APEX MAIN EMS STATION

6950 APEX BARBECUE ROAD, APEX, NORTH CAROLINA 27502 | WAKE COUNTY REQUEST FOR BIDS NUMBER: RFB-23-080

ADDENDUM NO. 2

DATE: OCTOBER 19, 2023

SHEET A101 – FLOOR PLAN

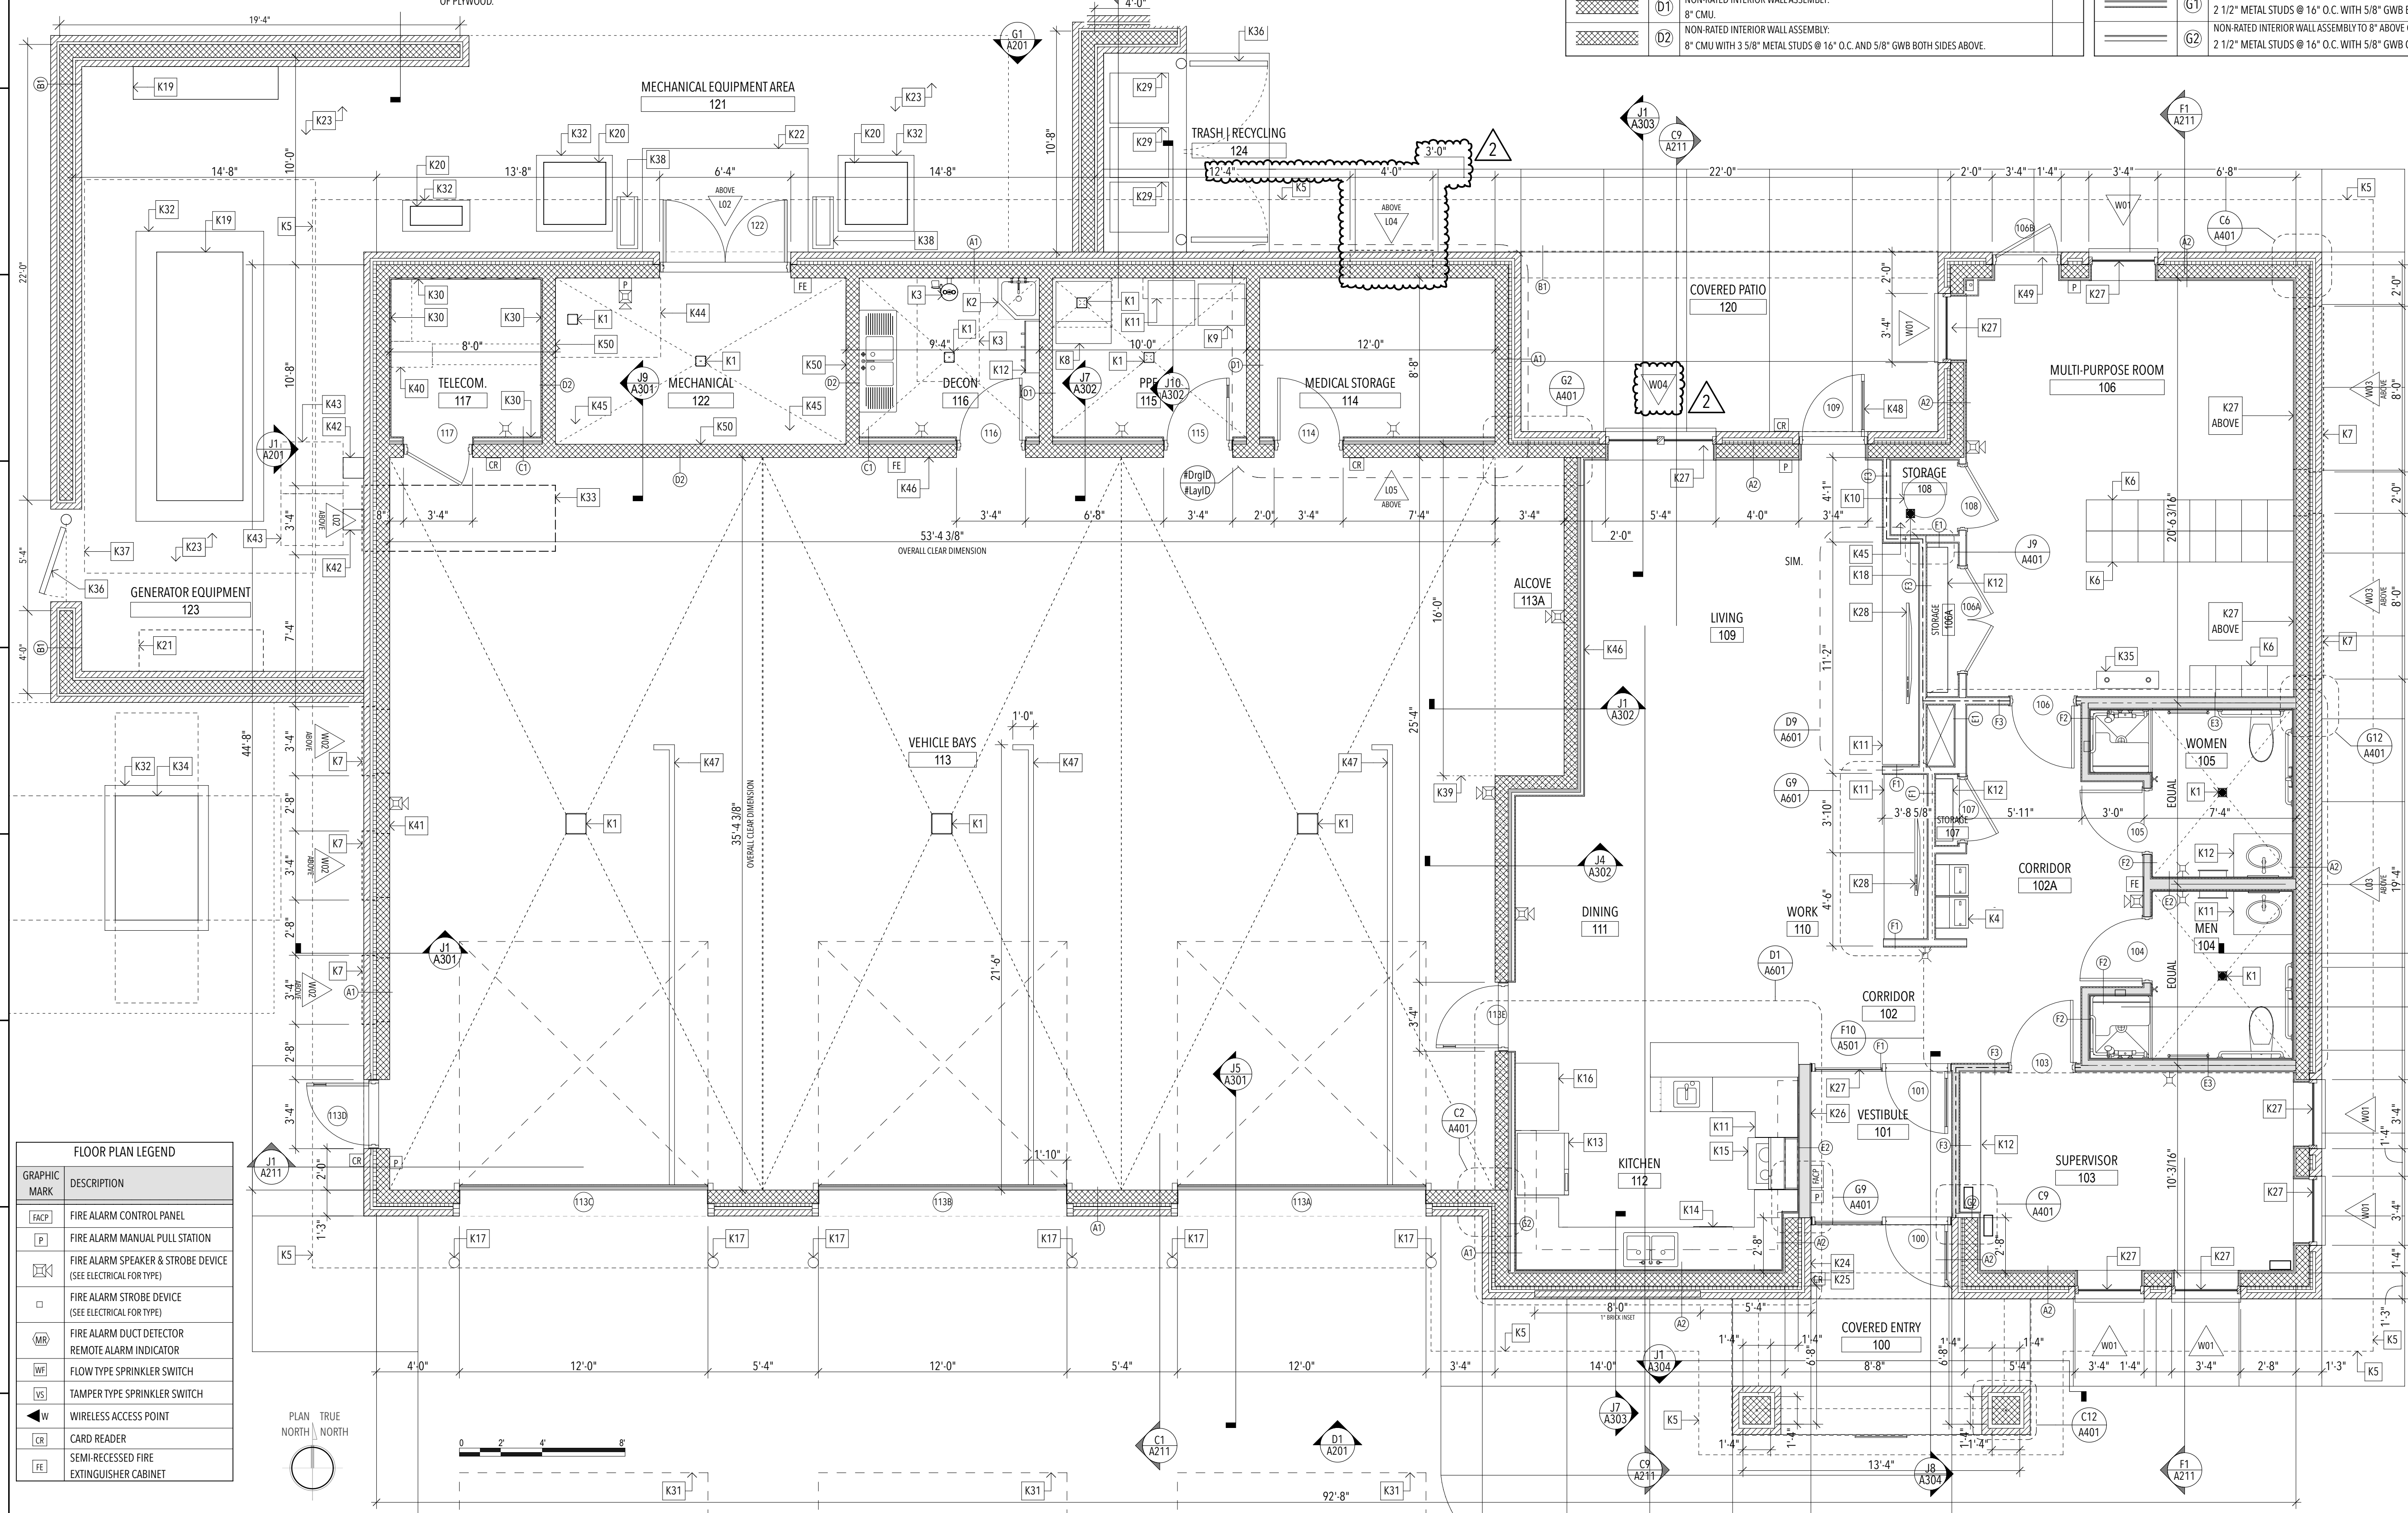
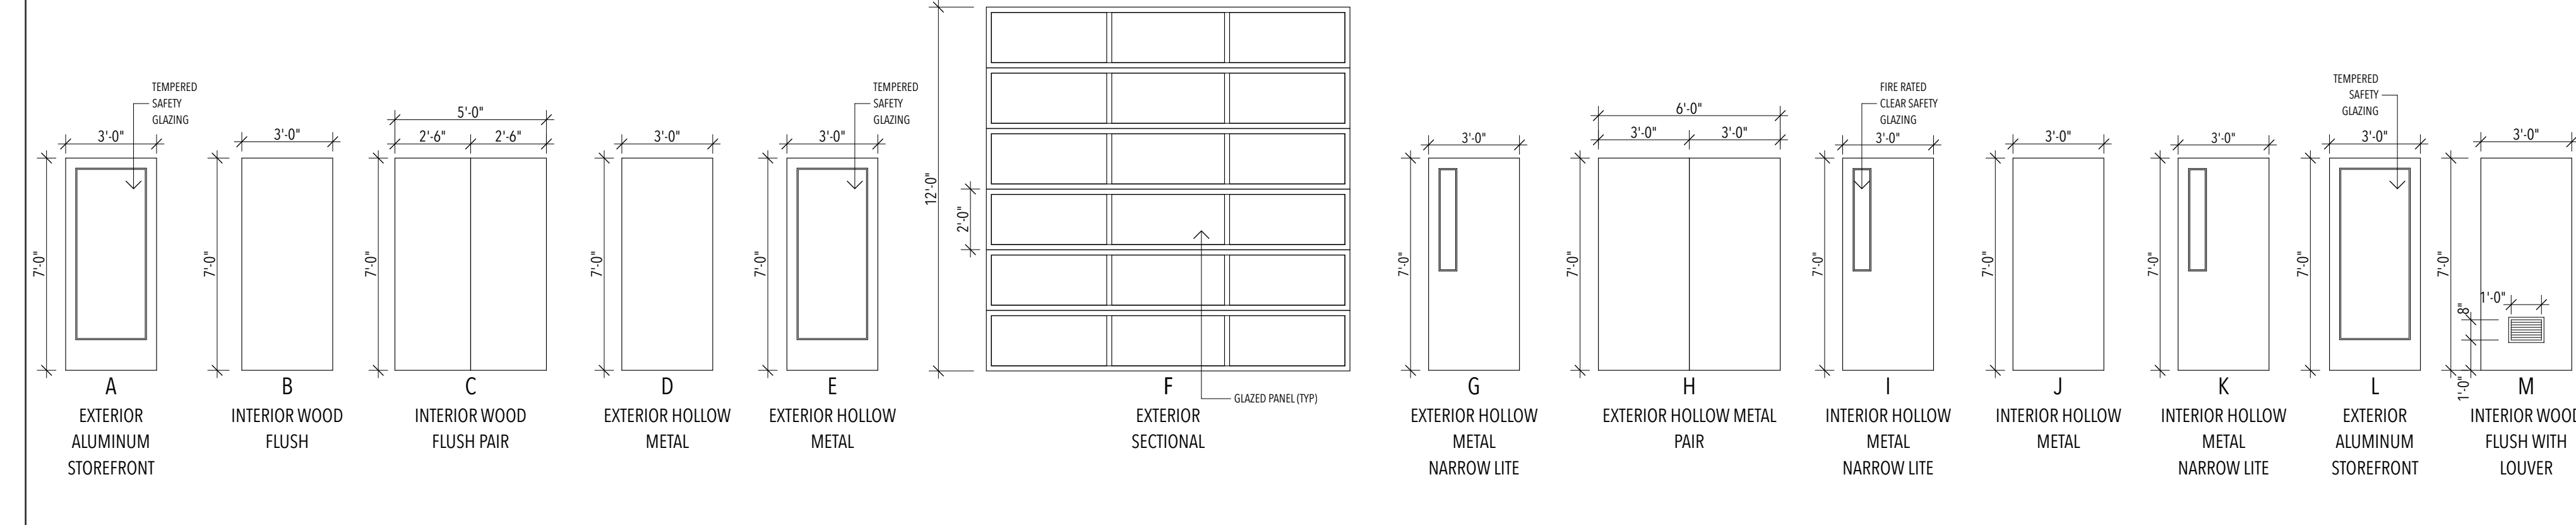
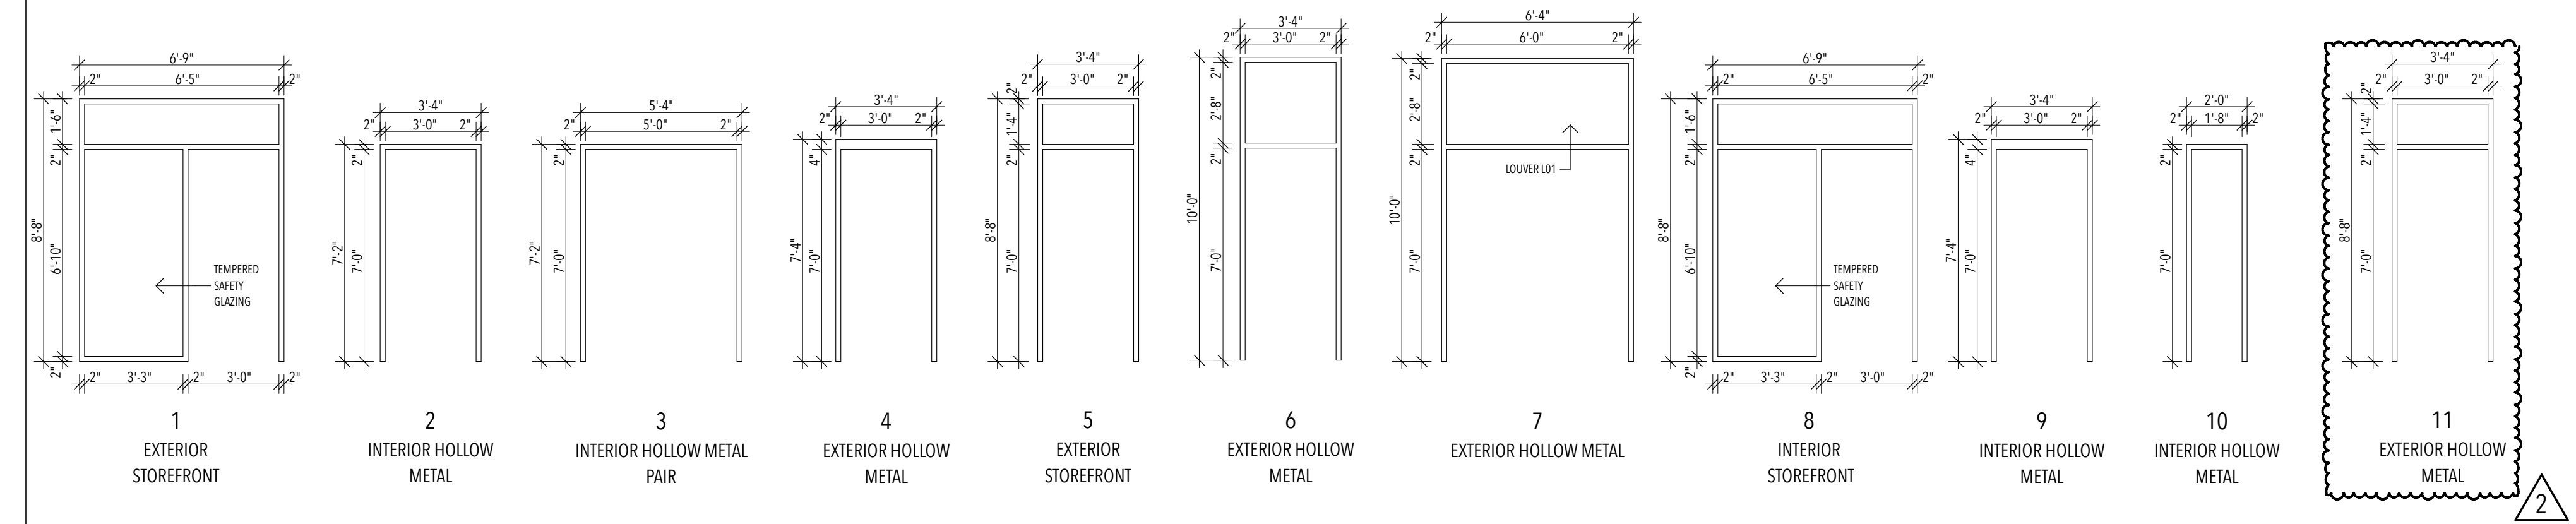
1. **REPLACE** Sheet A101 – Floor Plan with the attached, updated A101 – Floor Plan (Revision 2, Dated 10/19/23). Living 109 / Covered Patio 120 storefront window designation added. Louver L04 position updated to coordinate with location shown on Mechanical Drawing M101.

SHEET A701 – WINDOW & DOOR SCHEDULES & ELEVATIONS

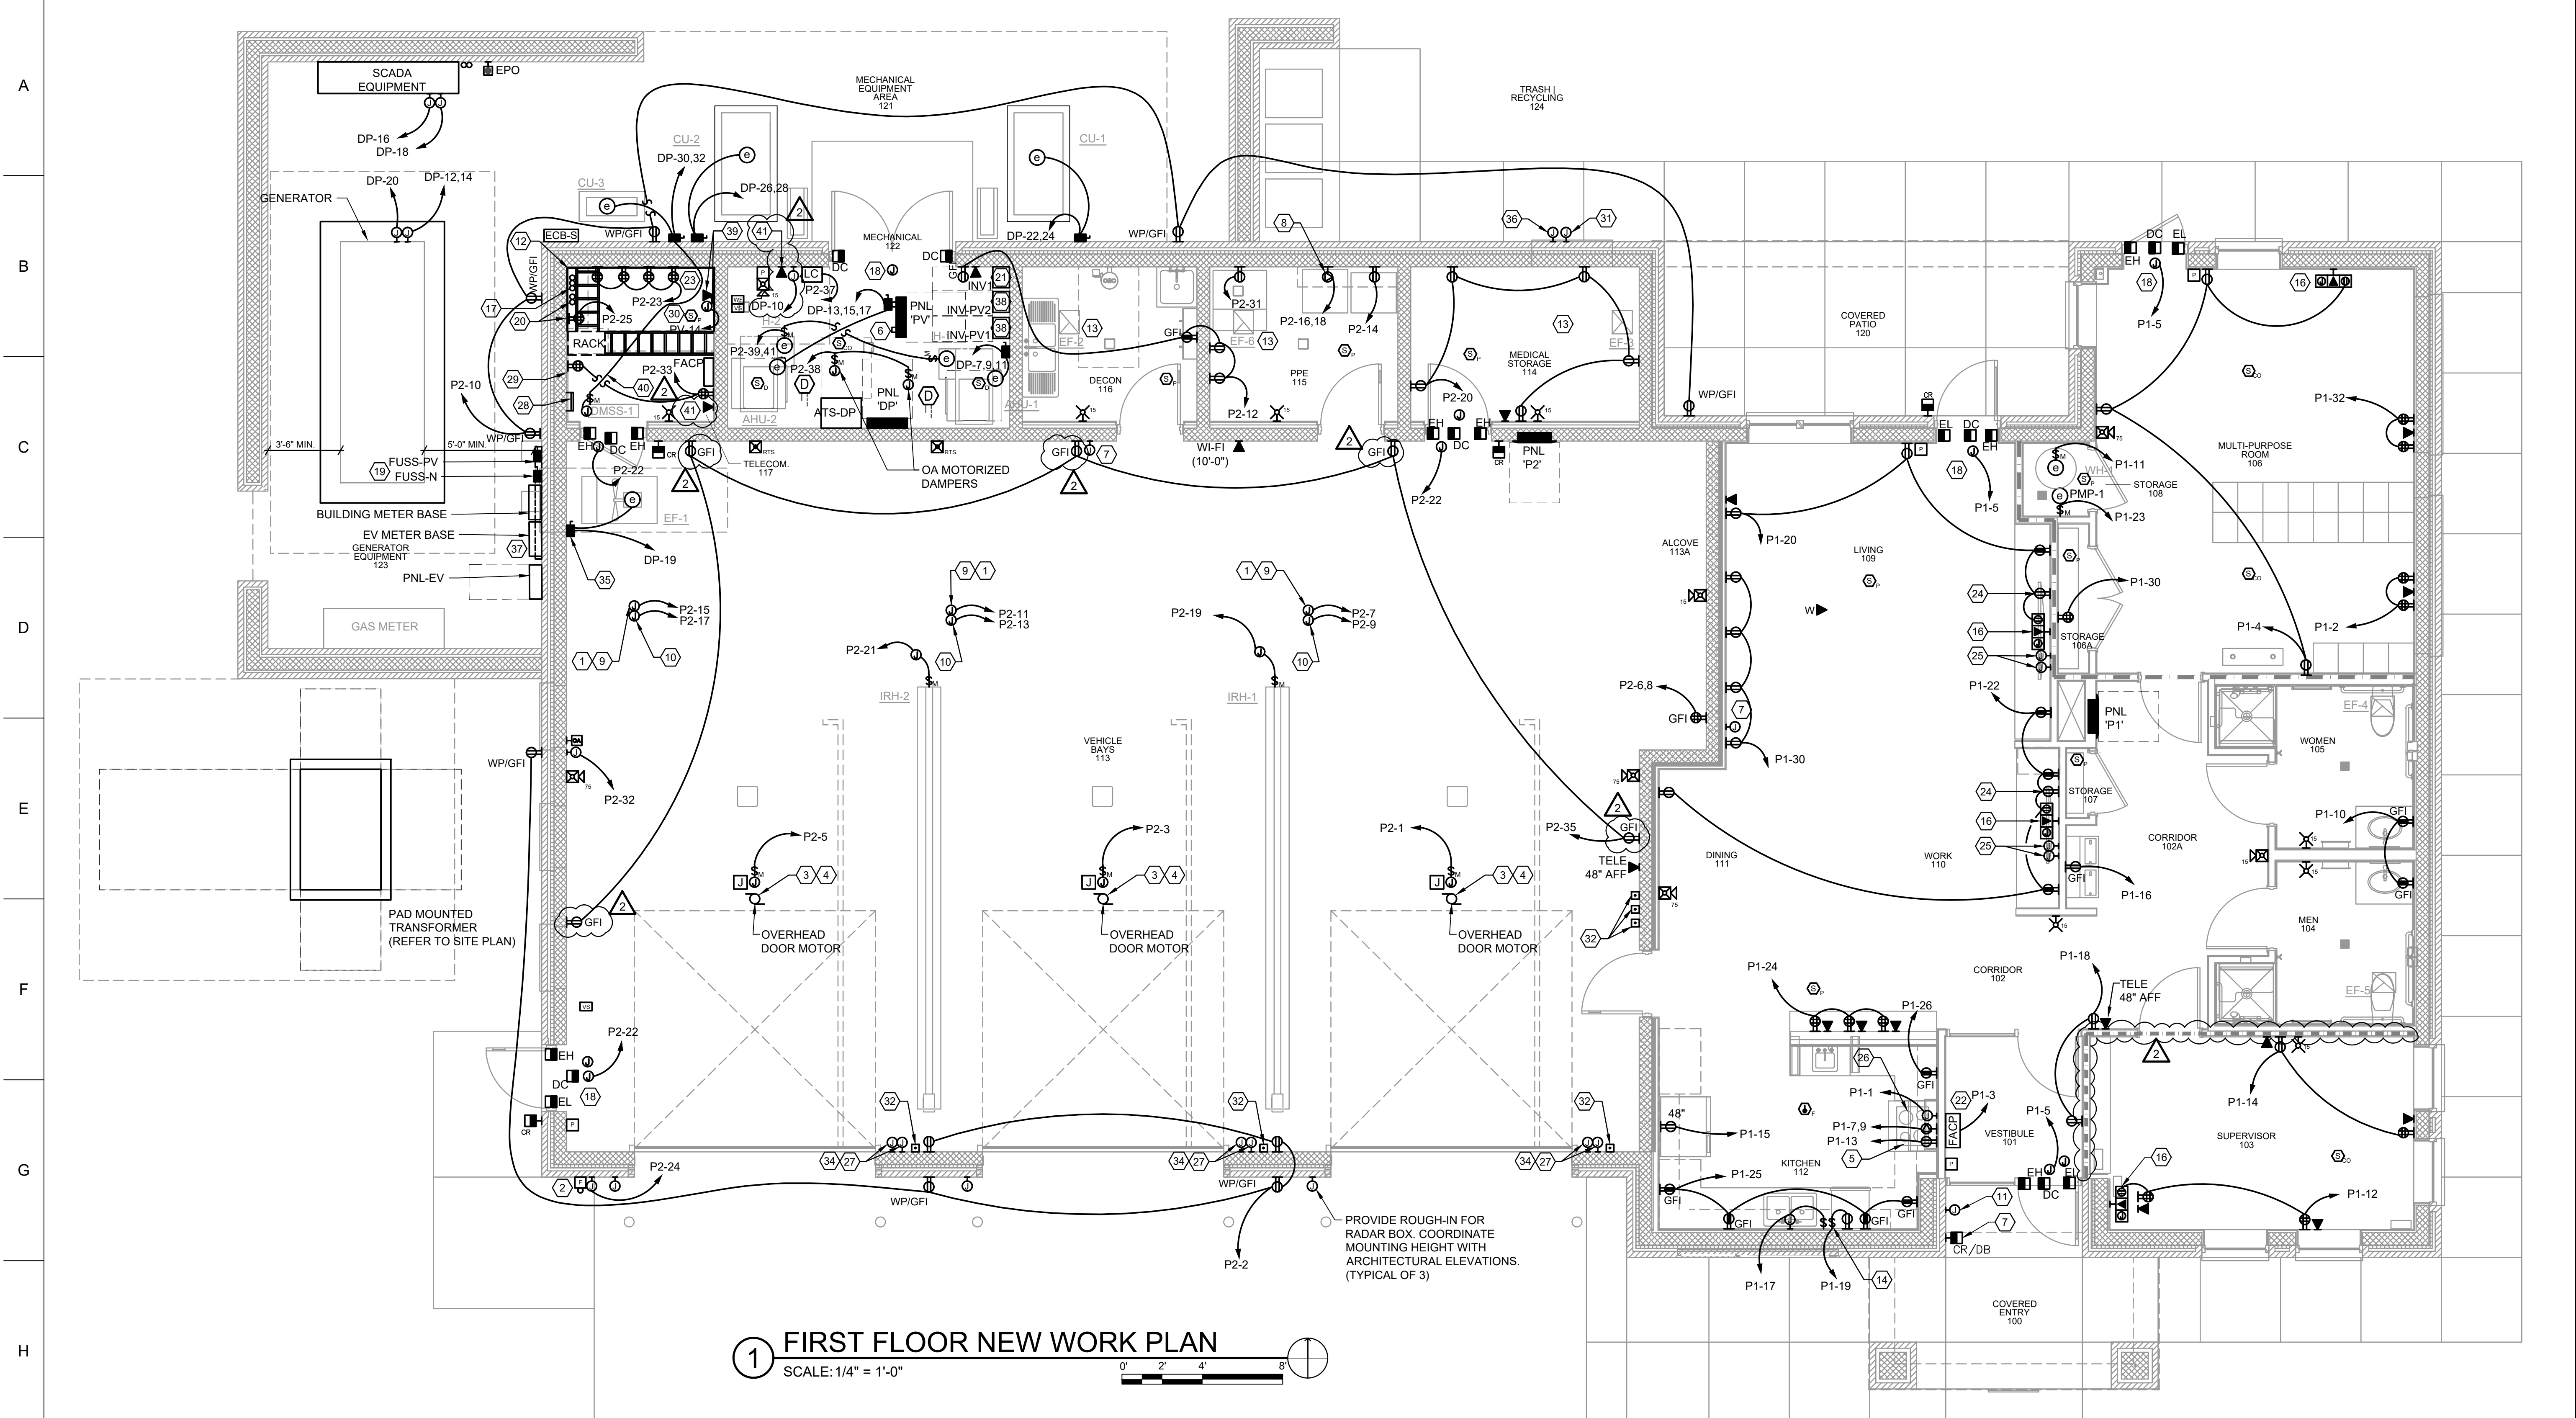
1. **REPLACE** Sheet A701 – Window & Door Schedules & Elevations with the attached, updated A701 – Window & Door Schedules & Elevations (Revision 2, Dated 10/19/23). Exterior Aluminum Storefront Window W05 and Exterior Hollow Metal Door Frame 11 elevations added to G5/A701 Window & Louver Elevations. Door 106B Door Frame Type revised to Exterior Hollow Metal Door Frame 11 on J5/A701 Door Schedule. Kerfed Frame (KF) previously added to Door 113E via text edit in Addendum 1 updated on revised drawing.
